**CAMDEN COUNTY PLANNING BOARD**  
**Land Development Review**

**Review List for Meeting**

**February 26th, 2019**

**CAMDEN COUNTY PLANNING BOARD  
COUNTY ENGINEER'S REVIEW  
OF SUBDIVISIONS AND  
SITE DEVELOPMENT PLANS**

**SITE PLAN**  
 FOR  
 822 BROADWAY  
 LOT(S) 22-28, 29 & 30.02  
 BLOCK 125, PLATE 31  
 COURTESY CITY  
 CADENZA COUNTY, NEW JERSEY  
 CHECKED: JAC  
 SHEET 3 OF 10  
 SCALE: 1" = 20'  
 DATE: 11/17/18  
 REVISIONS:

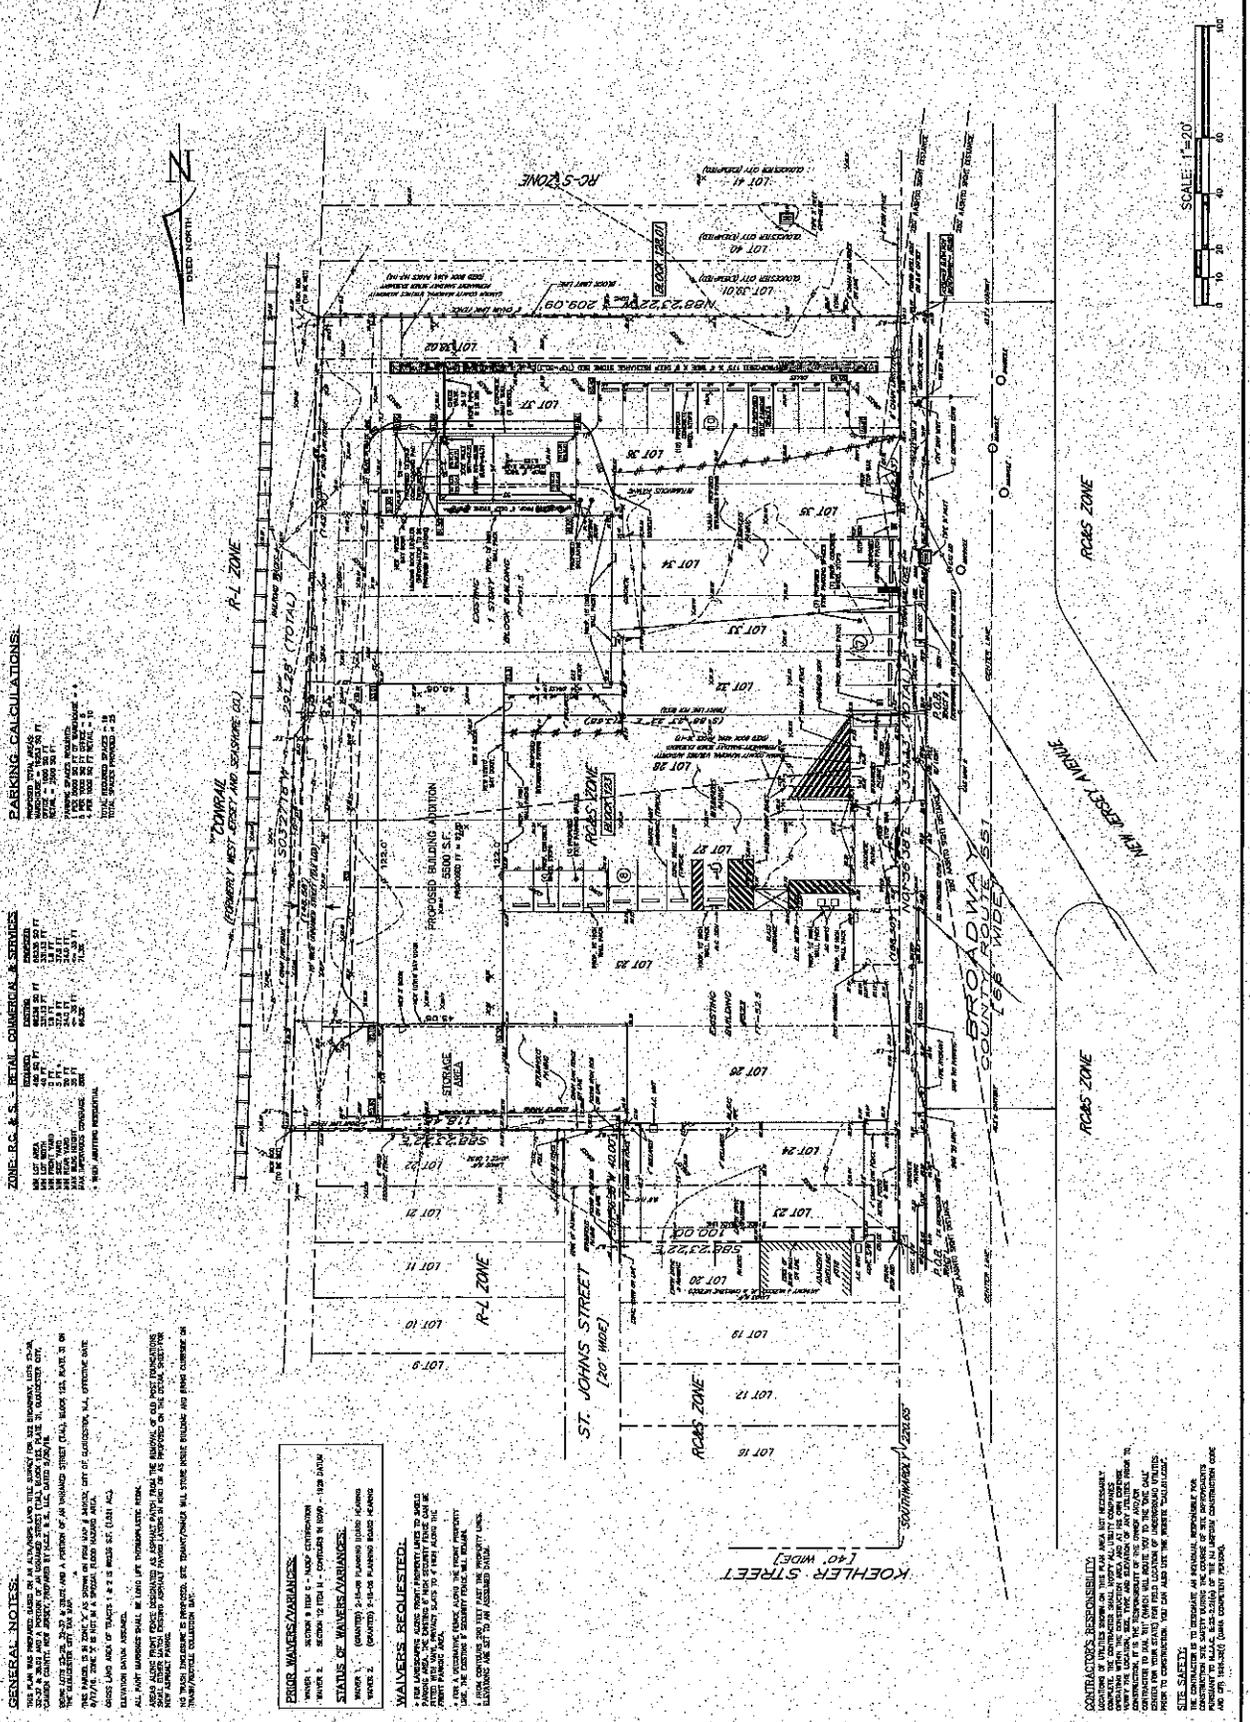
1. The Demolition Plan should clearly show all improvements to be removed within the County right-of-way.
2. In accordance with 3.3.1.1 common driveways to limit the number of conflicts along a County Road shall be encouraged or required as determined by the CE.

Both the Survey and Site Plan do not accurately portray the number of depressed curbs along the property frontage. Portions of Lot 32-34 contain a depressed curb along the property frontage that should be reflected on the Survey and Site Plan sheets. Furthermore, the depressed curb located just south of the main entrance that is locate between the two utilities poles seems to no longer serve a function is required to be removed and replaced with a standard County Curb.

The driveway apron on lots 35 and 36 is required to be replaced as it is in disrepair. Please include Detail 6 Standard Concrete Driveway and Concrete Apron and refer to regulations 3.3.1.10 D and 3.3.1.10.E for driveway radius and distance requirements.

3. The plans should include a note indicating "All sidewalk and curb within the County right-of-way along the property frontage that is deteriorated or presents a tripping hazard shall be replaced under the direction of the County Engineer or his/her representative.

The existing portions of the sidewalk that are asphalt shall be replaced with concrete using, Detail 5 County Standard Concrete Sidewalk.

5. In accordance with Section 3.5.1.A, all storm inlets adjacent to properties under development must meet stormwater regulations. The plans should be revised to provide a Bicycle safe grate at the Type “A” inlet along the property frontage.
